- 1 **Objection is sustained that AMEC's assessment of the impact of the Edinbane Wind Farm on golden eagles is unrepresentative and systematically underestimates the impact on golden eagles and the Cuillins SPA. Objection is sustained that the Edinbane Wind Farm will have a severe adverse impact on golden eagles and damage the conservation interest of the Cuillins SPA. It is requested that the Council either a) refuse consent for the Edinbane Wind Farm; or b) seek from AMEC a scientific assessment of the impact of the proposal on golden eagles and the Cuillins SPA, including rational mitigation proposals.**

Assessment of golden eagle blade strike risk

Figure 1: comparison of golden eagle flight data observed in watches during 2001 and 2002

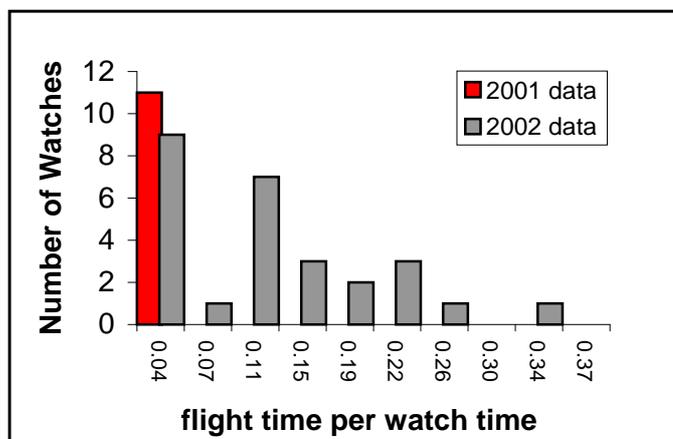
13 Comparison of the 2001 and 2002 data suggests that the sets may represent two distinct populations, and it is necessary to examine the methods of data collection.

Figure 3: the 20m A.G.L. visible areas in the wind farm envelope are shown shaded in yellow for each vantage point and in combination (increased cumulative visibility is indicated by darker shading).

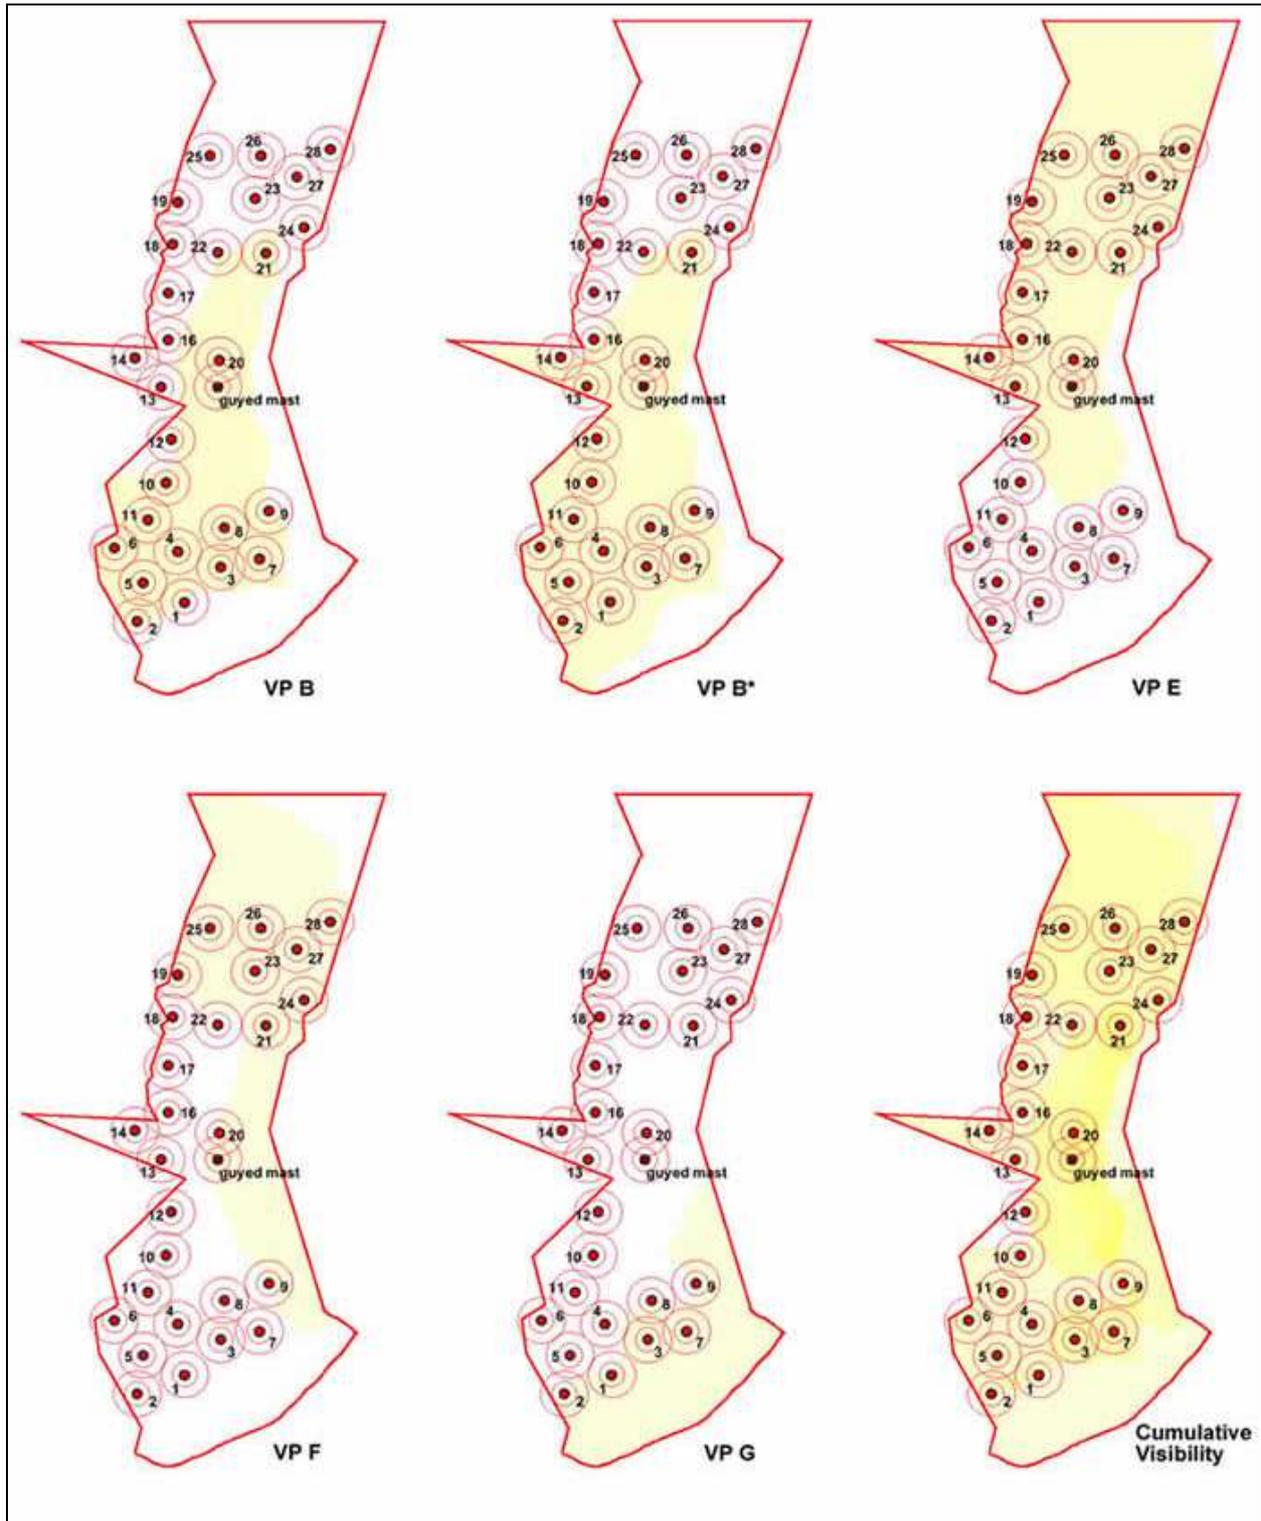
- 40 The determination of visible area is made as follows: AMEC's definition of 20m A.G.L. visibility from each vantage point is overlaid with the wind farm development boundary and the visible area within the wind farm development boundary masked and measured in a graphics program. The pixel count is converted to hectares by scaling to a known reference area. As a check, the 20m A.G.L. visibility area in a 360-degree field within 4 km around each vantage point is also determined for comparison with AMEC's 20m A.G.L. figures. For VP B, for which the area is not reported by AMEC, a conservative estimate of the visibility is made by reference to the topography.

- 41 The sizes of the 20m A.G.L. visibility areas in the wind farm envelope are shown in the table below, together with the check data for ‘within 4 km 360-degree 20m A.G.L. visibility area’, and the ‘within 4 km 360-degree 100m A.G.L. visibility area’ that was actually used by AMEC in its analysis.

Figure 4: Observed transits within 100m and 200m of turbines at 20-100m height (all transits, unadjusted for turbine watch time)

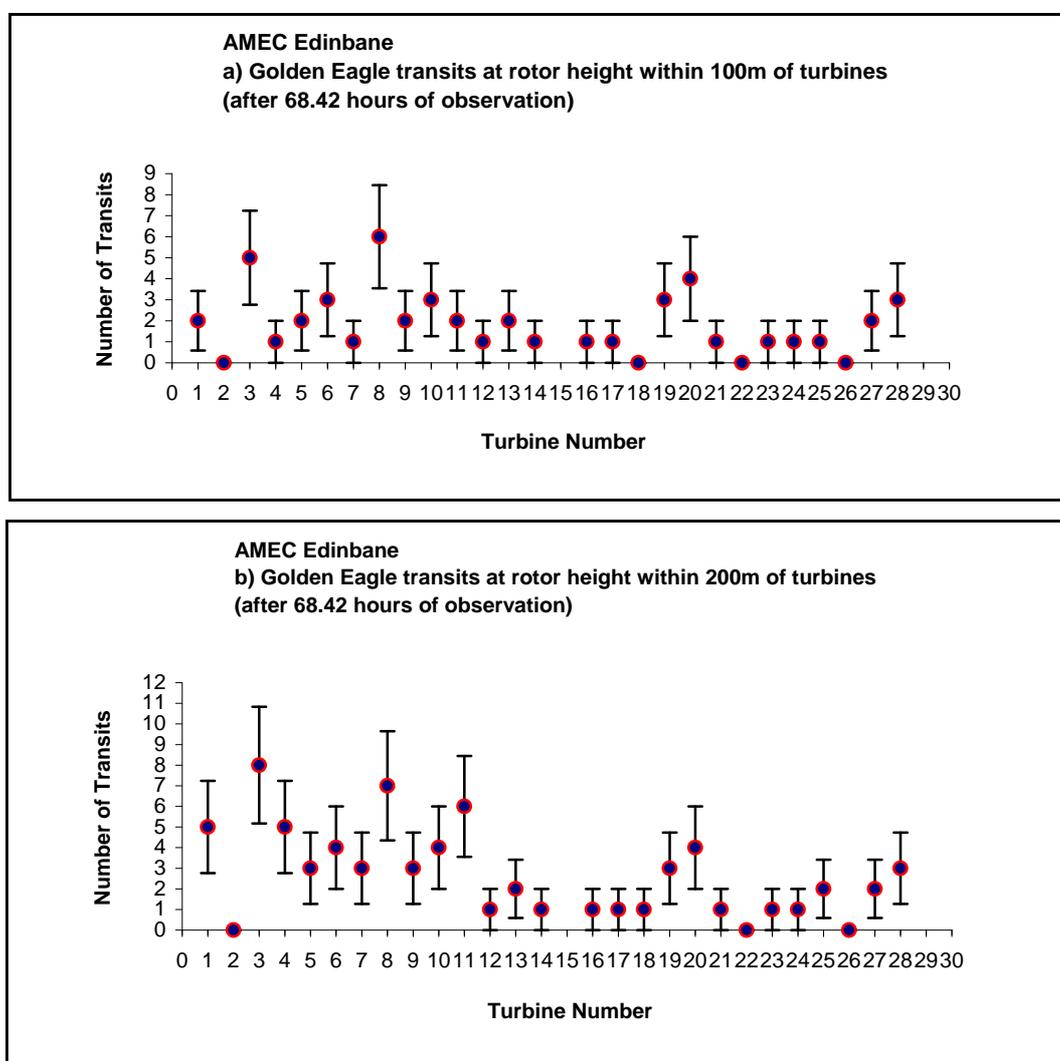
- 74 AMEC identifies⁵³ 4 turbines said to present 33% of the risk; however, there is insufficient data to reliably discriminate between individual turbines and AMEC's claims of statistically significant evidence of risk reduction arising from the removal of turbines 3, 10, 11, and 20 is rejected.

- 75 Note that the most frequently crossed turbines correlate with turbines having high cumulative visibility. Discrimination at the individual turbine level requires adjustment for turbine watch time, since turbines may have significantly different cumulative visibility from VPs used in non-simultaneous watches.
- 76 It is requested that the Council advise AMEC to collect further golden eagle flight data in order that the impact and mitigation of individual turbines might be analysed with reasonable statistical significance. This would also have the advantage of allowing a wind farm level estimate of the blade strike risk to the white-tailed eagles using the site⁵⁴.

Figure 5: Flights in the proximity of the guyed monitoring mast recorded after 68.42 hours of observation (red circles indicate 100m and 200m proximity zones around the mast).

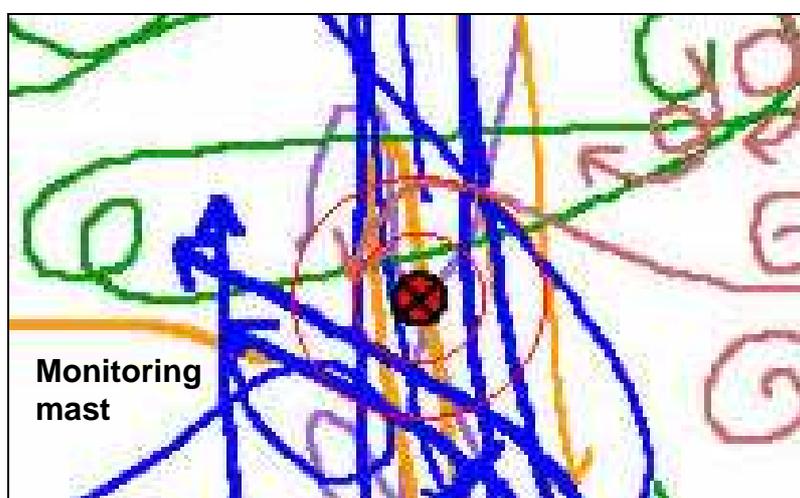
- 77 **Objection is lodged that the proposed location of the monitoring mast presents an unacceptable collision hazard to golden eagles.**
- 78 There are a significant number of transits in the area of the monitoring mast (including at least 5 within 100m in the 20-100m height band). AMEC propose that this structure will be supported by guy wires which are a known collision hazard, but offers no risk assessment for this structure.

- 79 It is requested that the Council advise AMEC to perform appropriate assessment of the impact of the monitoring mast on golden eagles and to consider alternative constructions and locations for this structure.
